## 19L ABWR Shutdown Risk Evaluation

The information in this appendix of the reference ABWR DCD, including all subsections, tables, and figures, is incorporated by reference with the following departures.

Figure 19L-3 Potential Path for Draining RPV Through Residual Heat Removal System (Pump On)

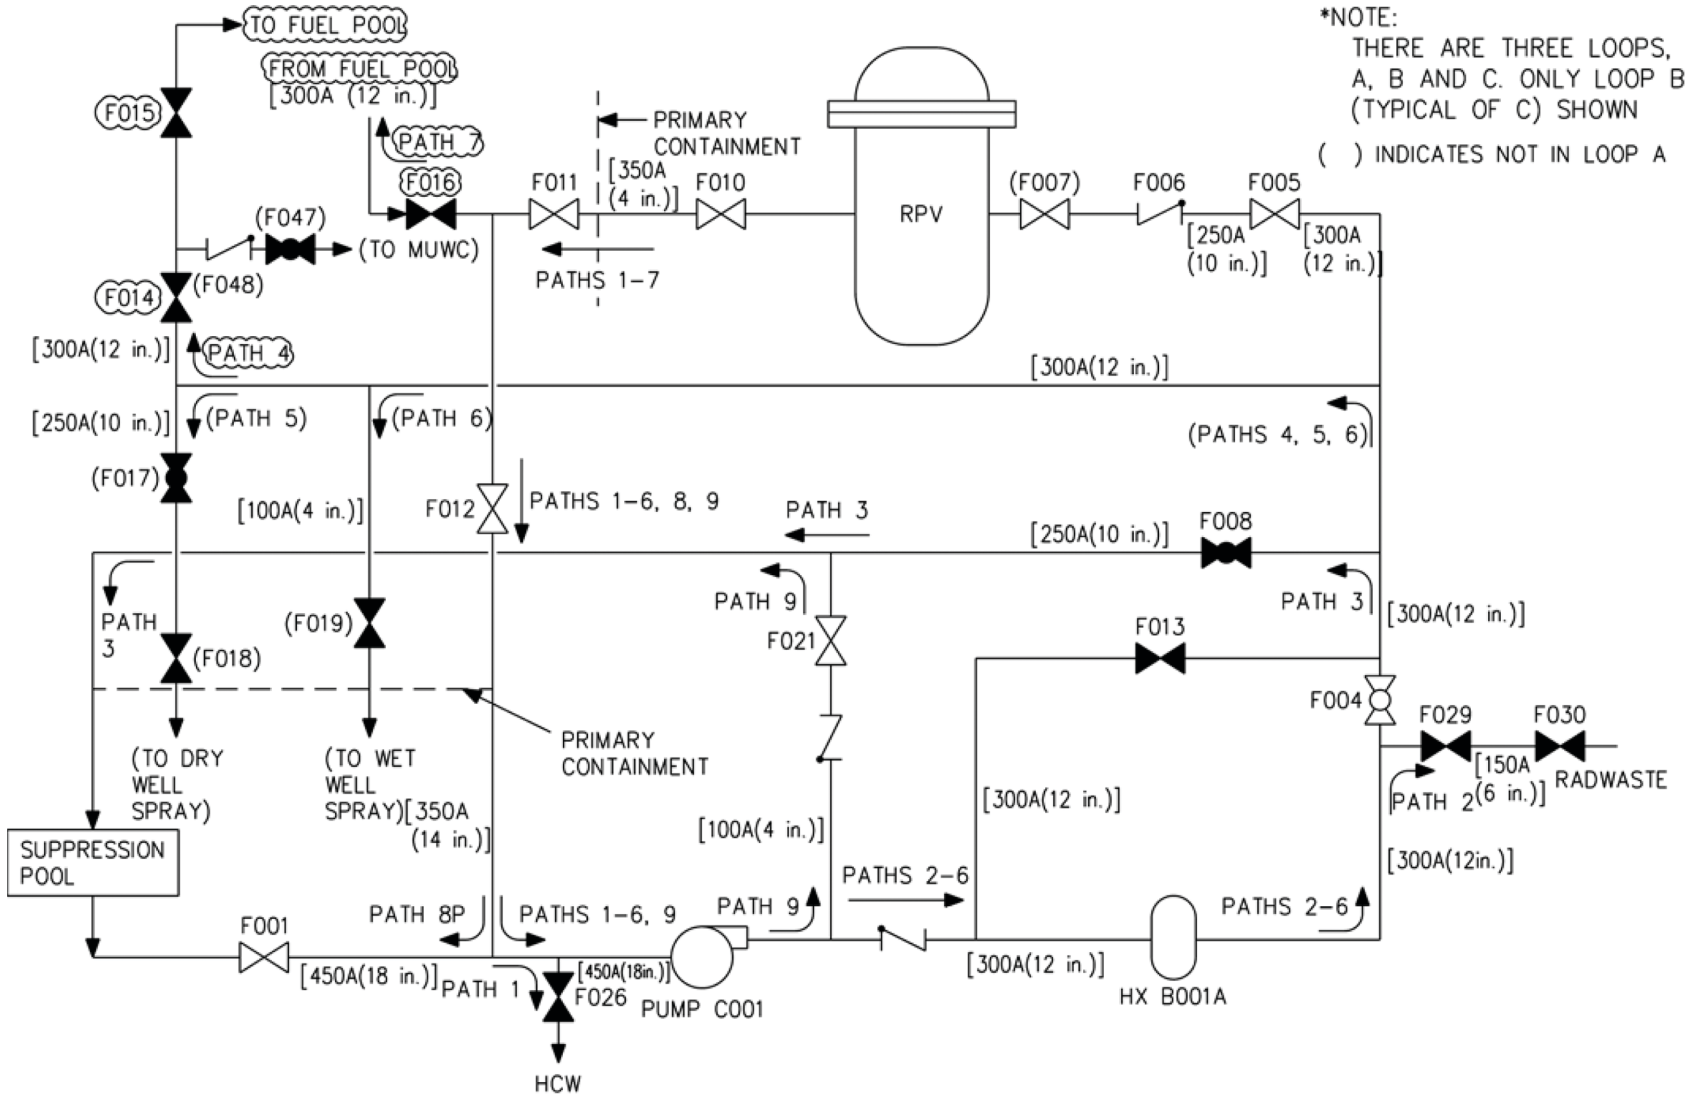
STD DEP T1 2.4-1 (Figure 19L-3)

STD DEP T1 2.4-1

*The ABWR residual heat removal (RHR) system is a closed system consisting of three independent pump loops (A, B, and C-where B and C are similar) which inject water into the vessel and/or remove heat from the reactor core or containment. Loop A differs from B and C in that its return line goes to the RPV through the feedwater line whereas loop B & C return lines go directly to the RPV. In addition, loop A does not have connections to the drywell or wetwell sprays. ~~or a return to the fuel pool cooling system.~~ However, for purposes of this analysis, the differences are minor and the three loops can be considered identical. The RHR system has many modes of operation, each mode making use of common RHR system components. These components are actuated by the operator; hence, the operation is subject to operator error which could potentially lead to drainage of the RPV. Potential paths for draining the RPV through the RHR system during operating Modes 4 and 5 are discussed below, summarized in Table 19L-8 and depicted in Figure 19L-3. Of the various modes of RHR operation it was judged that the potential for RPV draining was the greatest during the shutdown cooling mode. Therefore, the potential RPV draining paths start with the RHR in the shutdown cooling mode of operation. As will be shown by the following consideration and analysis, the probability of draining the RPV through the RHR system is negligibly low. Even if all the preventive and mitigative features fail, RPV draining will stop when the RHR shutdown cooling nozzle is uncovered at which point there is still 1.6 meters of water over the top of the active fuel.*
